Contract #: 04-0120F4Cty: SF/ALA Rte: 80 PM: 13.2/13.9File #: 69.25B**QUALITY ASSURANCE -- NON-CONFORMANCE REPORT****Location:** Changxing Island, Shanghai, P.R. China**Report No:** NCR-000915**Prime Contractor:** American Bridge/Fluor Enterprises, a JV**Date:** 23-Nov-2010**Submitting Contractor:** Zhenhua Port Machinery Company, Ltd (ZPMC), Changxing Island**NCR #:** ZPMC-0877**Type of problem:****Welding****Concrete****Other****Welding****Curing****Procedural****Bridge No:** 34-0006**Joint fit-up****Coating****Other****Component:** Bikepath BK004C2-024**Procedural****Procedural****Description:**

QUALITY ASSURANCE -- NON-CONFORMANCE REPORT

NCR PROPOSED RESOLUTION

Contract #: 04-0120F4Cty: SF/ALA Rte: 80 PM: 13.2/13.9File #: xx.25A**QUALITY ASSURANCE -- NON-CONFORMANCE RESOLUTION****Location:** Changxing Island, Shanghai, P.R. China**Report No:** NCS-000919**Prime Contractor:** American Bridge/Fluor Enterprises, a JV**Date:** 23-Feb-2011**Submitting Contractor:** Zhenhua Port Machinery Company, Ltd (ZPMC), Changxing Island **NCR #:** ZPMC-0877**Type of problem:**

-The weld is identified as BK004C2-024-018, 016.

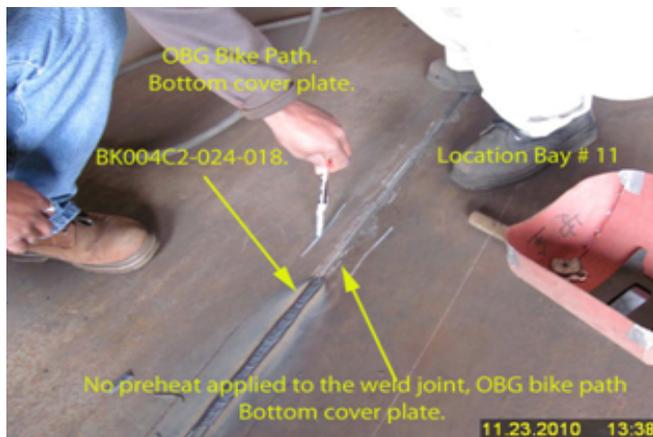
ZPMC welding personnel did not follow the "Weld Procedure Requirements for New Welds" by Rager/McQuaid

-The area was being not preheated to 165 degrees.

-ZPMC personnel did not inspect 100% VT and MT of backgouged area before welding began from the second side.

Reference Resolution: As this NCR was written without a contractual basis it should be withdrawn.

CT acknowledges contractor's response. However, successful NDT will close this NCR.

Normal NCR closure package with NDT reports shall be submitted with the NPR to close out the NCR.

See attached NDT results to show the weld is acceptable. Based on this ZPMC requests closure of this NCR.

This proposed resolution is acceptable. The documentation received is sufficient and the Department concurs that Non-Conformance ZPMC-0877 is closed.

-The weld is identified as BK004C2-024-018, 016.

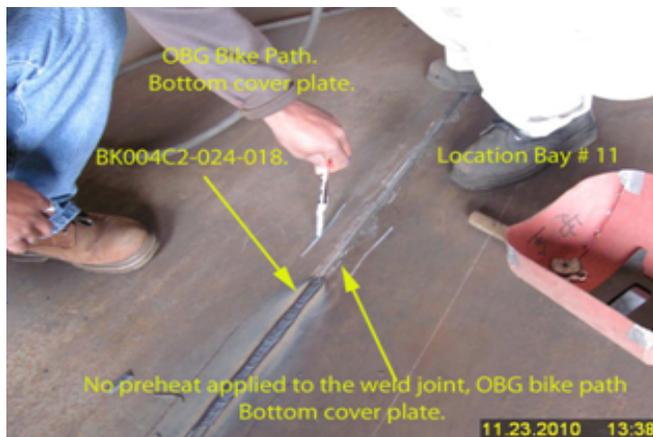
ZPMC welding personnel did not follow the "Weld Procedure Requirements for New Welds" by Rager/McQuaid

-The area was being not preheated to 165 degrees.

-ZPMC personnel did not inspect 100% VT and MT of backgouged area before welding began from the second side.

Contractor will provide the NDT report to prove the weld is acceptable.

Contractor provided the NDT report. The report proves the weld is acceptable.
